Transmitted by the chairmen of the informal group on pedestrian safety

**PROPOSAL FOR A GLOBAL TECHNICAL REGULATION ON
UNIFORM PROVISIONS CONCERNING THE APPROVAL OF VEHICLES WITH
REGARD TO THEIR CONSTRUCTION IN ORDER TO IMPROVE THE PROTECTION
AND MITIGATE THE SEVERITY OF INJURIES TO PEDESTRIANS AND OTHER
VULNERABLE ROAD USERS IN THE EVENT OF A COLLISION**

Note: The text reproduced below was prepared by the informal group in order to amend and replace TRANS/WP.29/GRSP/2005/3.

Pedestrian Safety Global Technical Regulation Preamble

Figure 6: Impact and target ~~Pointpoint~~—(*insertion of impact angle example*) (see paragraph §3.17. and paragraph §3.23.)

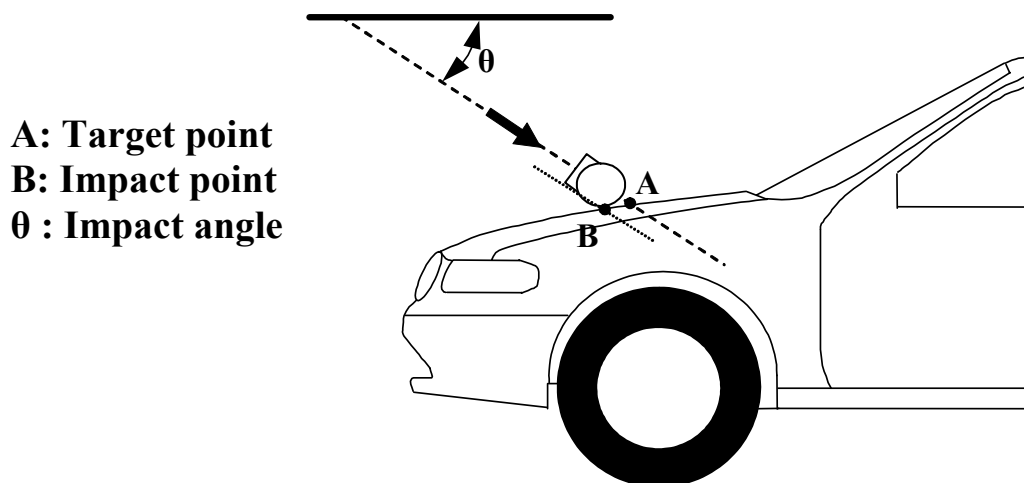
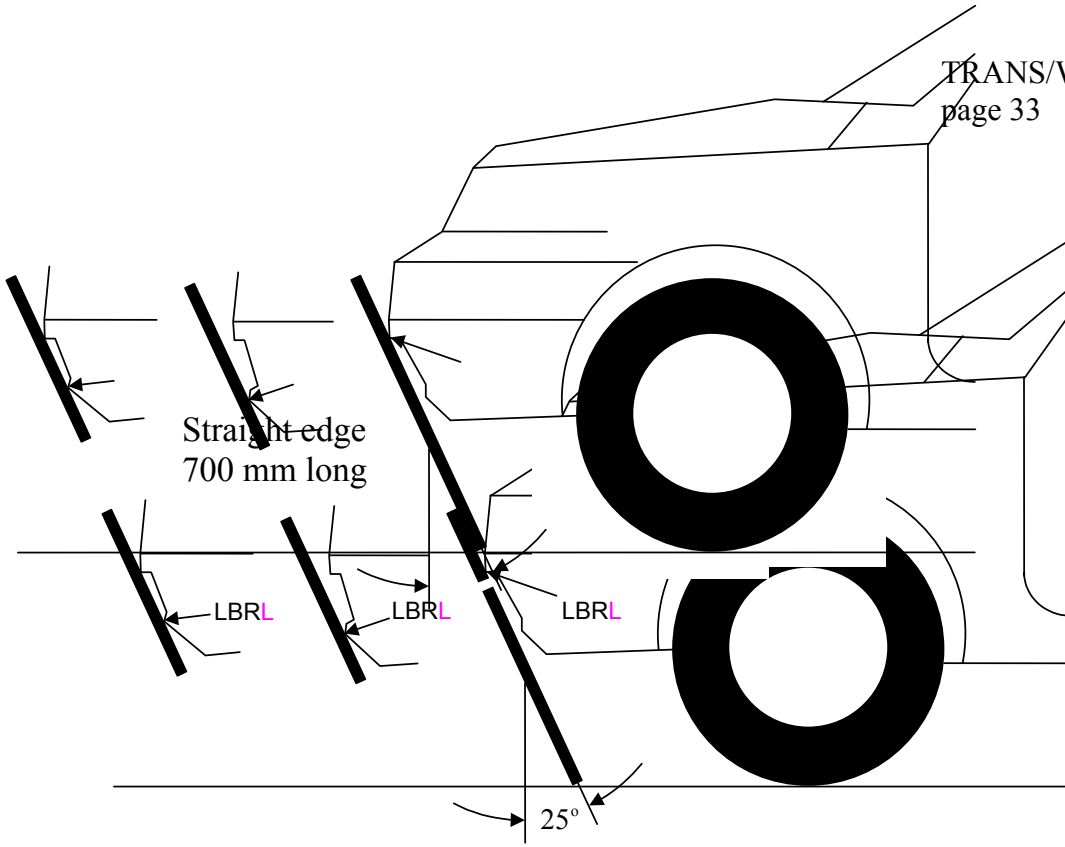
Figure 6 could be used to provide an example of the measured angle.

[Figure 13c: Windscreen ~~Lower-lower Reference-reference Line~~line (see §paragraph 3.31.)
This diagram requires more discussion and agreement.

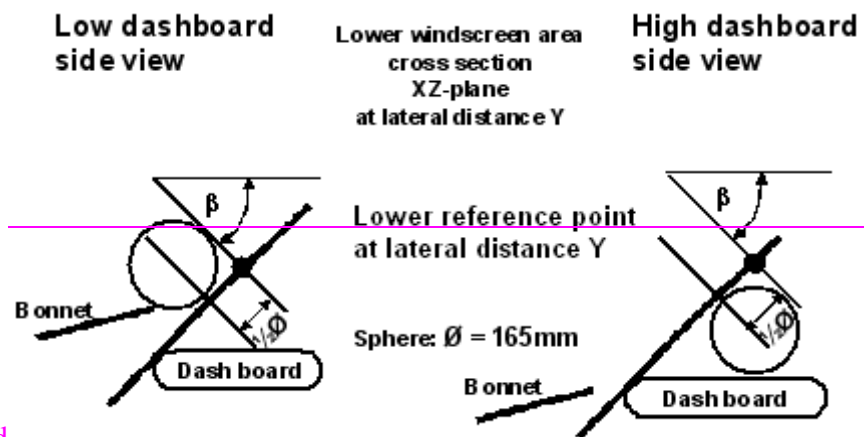
Figure to be created

- 3.3230. "Windscreen" means the frontal glazing of the vehicle situated between the ~~—~~A-pillars.
- 3.3331. "Windscreen lower reference line (LWL)"
*to be defined, see Figure 13c. **Definition to be proposed by EC.***

Figure 20: Bonnet Top Zone A and Bonnet Top Zone B

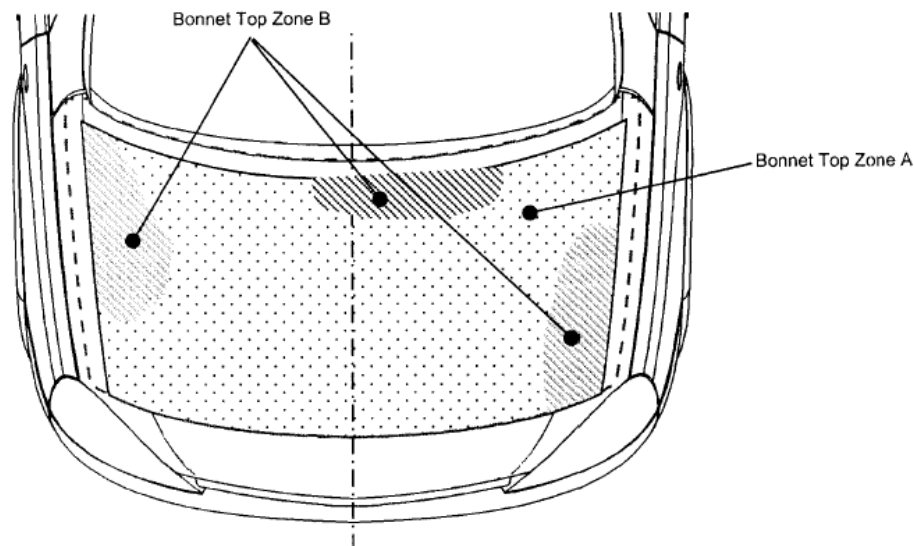
7.2.4.1 The manufacturer shall identify the zones of the bonnet top where the Head Performance Criterion (HPC) must not exceed 1000 (Bonnet Top Zone A) respectively [1700] (Bonnet Top Zone B), according to the technical requirements set out in paragraph 5.2 (see Figure 20).
